Access Compliance Report Public Rights-of-Way (Curb Ramps)

Intersection ID: 10023486 Main Street: CIRCUMFERENTIAL_RD Cross Street: N/A Location: NE

ADA ID: 54C9CFD2FFD7 Ramp Type: Directional1 Initial Pass/Fail: Fail Overall Compliance: No Severity Score: 1.25

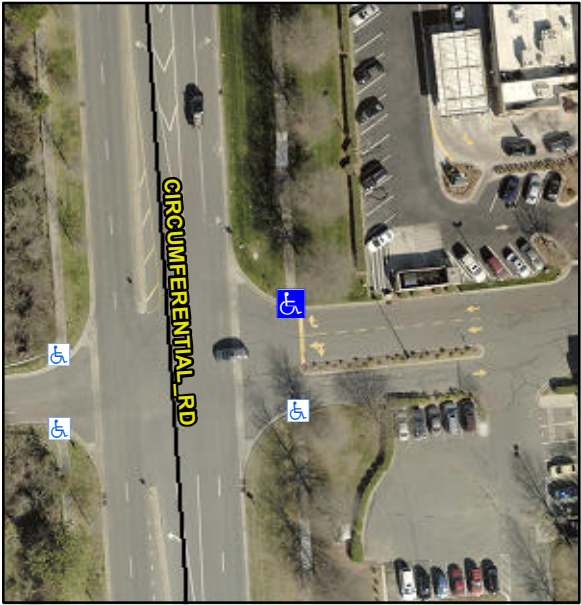
PROW/ADA:
R304.5.3

Compliance	Description	Data	Compliance	Description	Data
N/A	Ramp Length (in)	61.0	N/A	Grade Break?	N/A
Yes	Ramp Width (in)	58.0	N/A	Grade Break Slope (%)	0.0
Yes	Ramp Slope (%)	1.2	N/A	Grade Break XSlope (%)	0.0
No	Ramp XSlope (%)	3.3			
N/A	Flare Type LT	N/A	N/A	Flare Type RT	N/A
N/A	Flare Slope LT (%)	N/A	N/A	Flare Slope RT (%)	0.0
N/A	Flare Traversable LT?	N/A	N/A	Flare Traversable RT?	N/A
N/A	Landing Length (in)	0.0	N/A	DWS Provided?	N/A
N/A	Landing Width (in)	0.0	N/A	DWS Contrast?	N/A
N/A	Landing Slope (%)	0.0	N/A	DWS Length (in)	N/A
N/A	Landing X Slope (%)	0.0	N/A	DWS Full Width?	N/A
N/A	Landing Curb? (Y/N)	N/A	N/A	DWS Offset LT (in)	N/A
N/A	Shared Landing?	N/A	N/A	DWS Offset RT (in)	N/A
N/A	Gutter Ponding?	0.0	N/A	Gutter Slope (%)	N/A
N/A	Gutter Lip Ht (in)	0.0	N/A	Gutter X Slope (%)	N/A
N/A	Painted X Walk1?	No		Road Slope (%)	1.6
	X Walk 1 Direction	To S		Road X Slope (%)	4.2
	X Walk 1 Width (in)	N/A		Clear Space?	N/A

Possible Solutions:
Remove & Replace Entire Ramp.
